HISTORIC AND DESIGN REVIEW COMMISSION

May 04, 2022

HDRC CASE NO:	2022-242
ADDRESS:	527 E DEWEY PLACE
LEGAL DESCRIPTION:	NCB 2964 BLK 3 LOT 7 & E 12 FT OF 6
ZONING:	MF-33, H
CITY COUNCIL DIST.:	1
DISTRICT:	Tobin Hill Historic District
APPLICANT:	Jonathan Taylor/Champion Window Company
OWNER:	Margaret Halsema/HALSEMA MARGARET
TYPE OF WORK:	Porch enclosure
APPLICATION RECEIVED:	April 14, 2022
60-DAY REVIEW:	Not applicable due to City Council Emergency Orders
CASE MANAGER:	Claudia Espinosa

The applicant is requesting a Certificate of Appropriateness for approval to enclose the existing, rear covered porch.

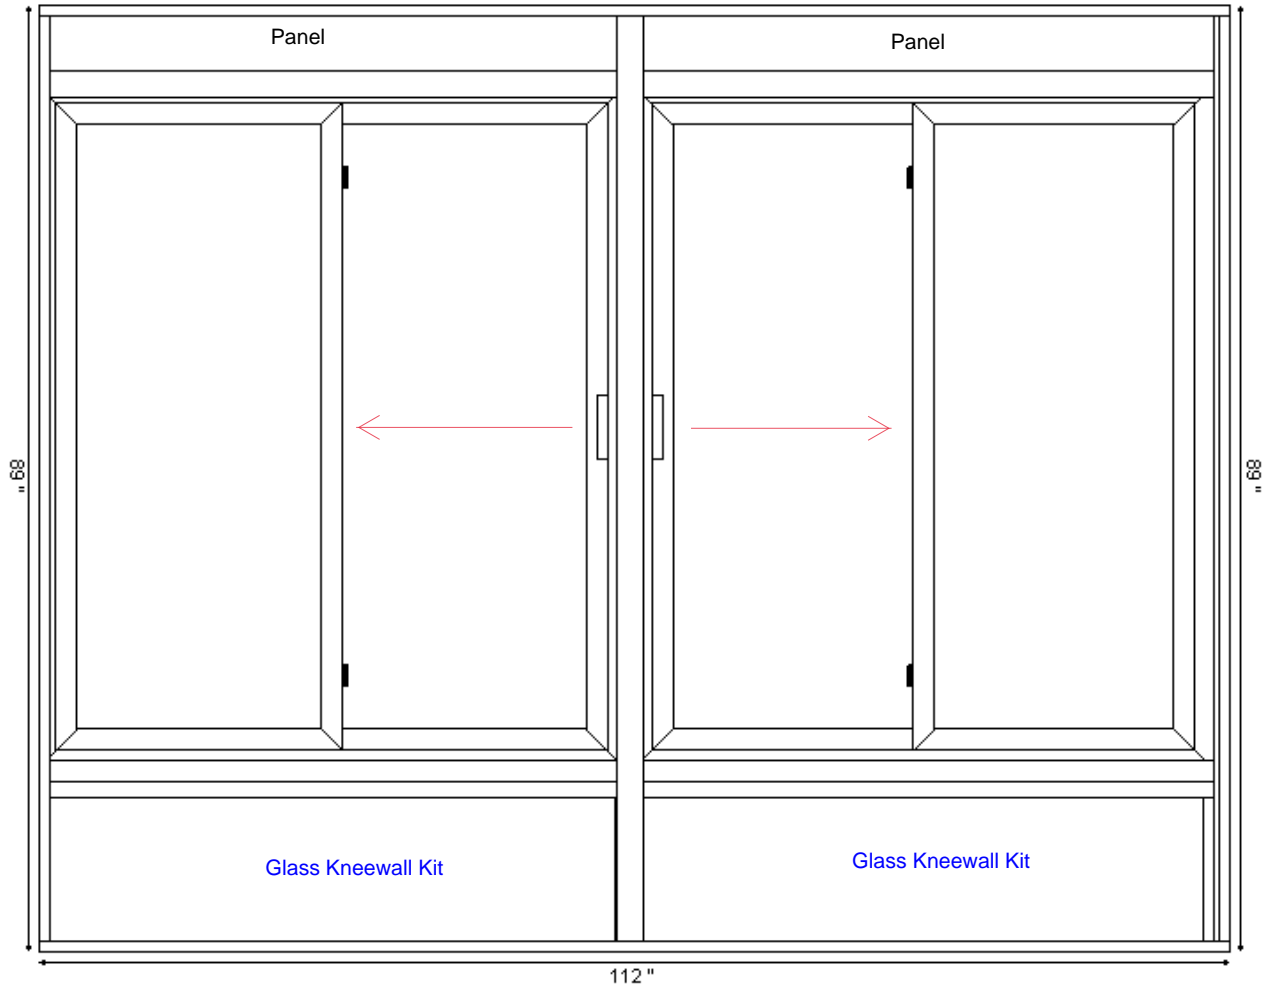
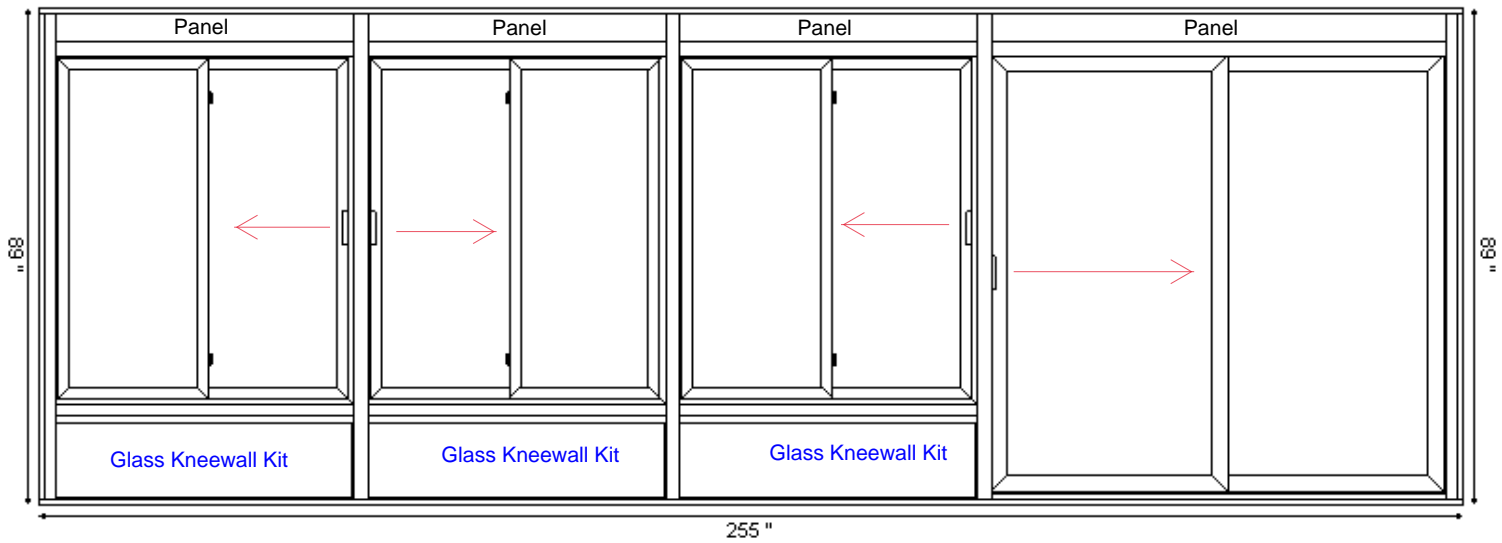
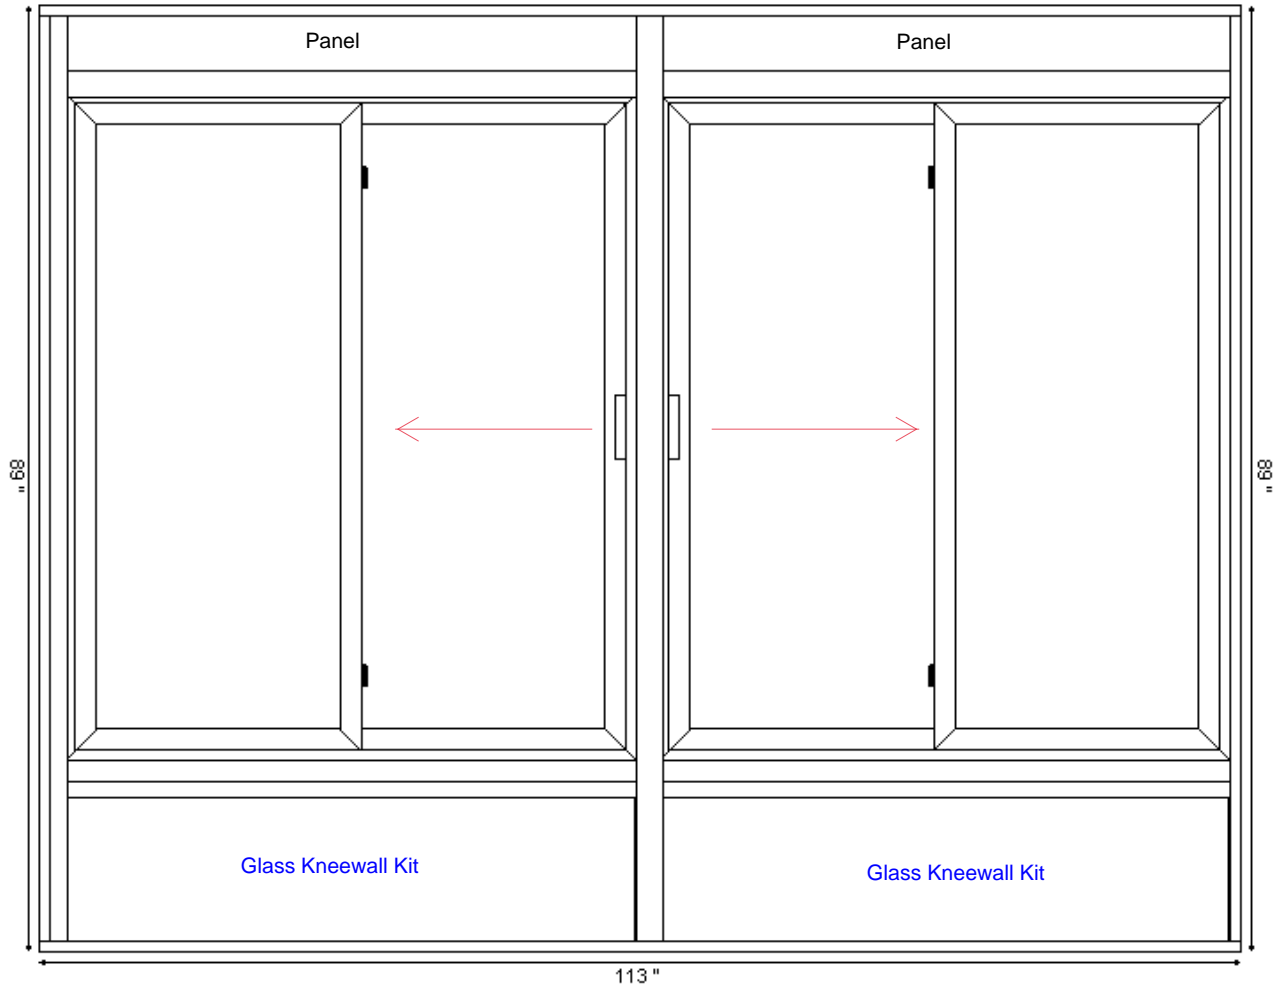
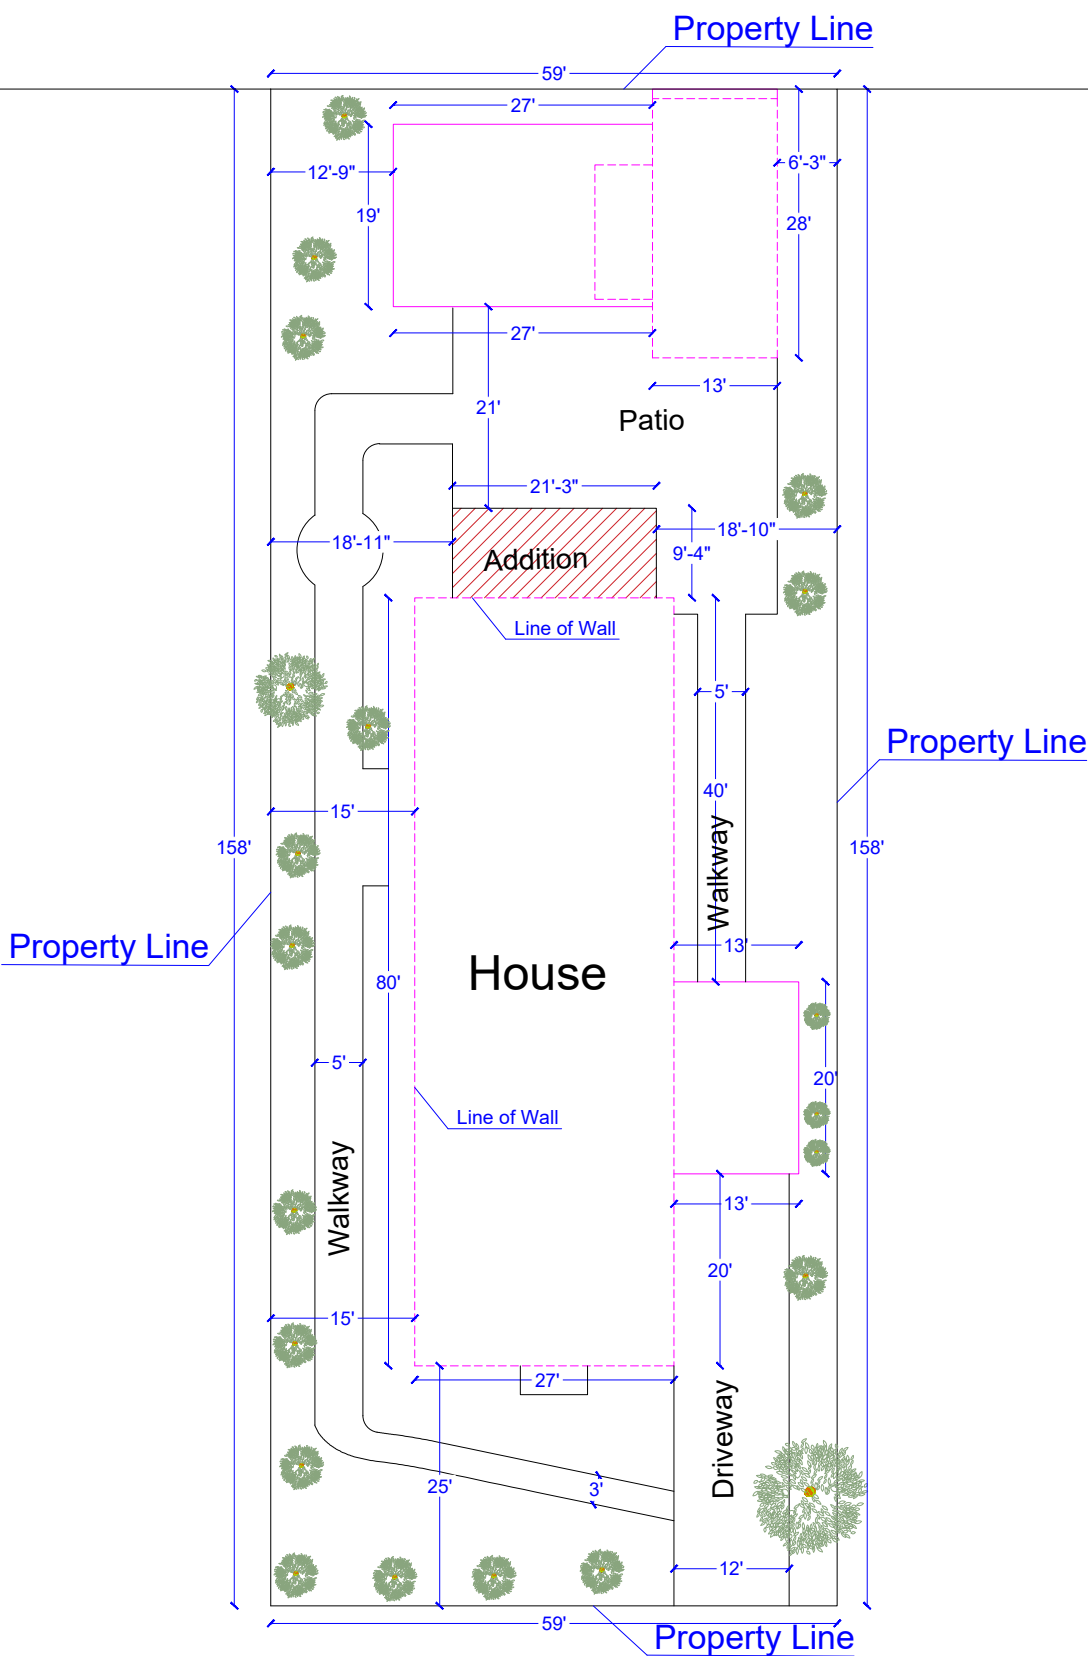
- a. The primary structure located at 527 E Dewey Place is a 1-story single-family home constructed circa 2003. The home features stucco, a flat roof, and vinyl windows.
- b. SCOPE OF WORK – The applicant has proposed to enclose the existing porch structure located at the rear of the property to create an enclosed sunroom. A Glass Kneewall Kit will be added to the north, east, and west elevations. The proposed windows and doors will feature aluminum frames. The overall footprint and roof form will not be modified. Generally, staff finds the proposed enclosure to be appropriate; however, staff finds that the enclosure should feature windows and doors with dark colored frames.

Staff recommends approval based on finding b with the following stipulation:

- i. That the installed window and doors feature dark colored frames, or a non-manufacturer's white color.
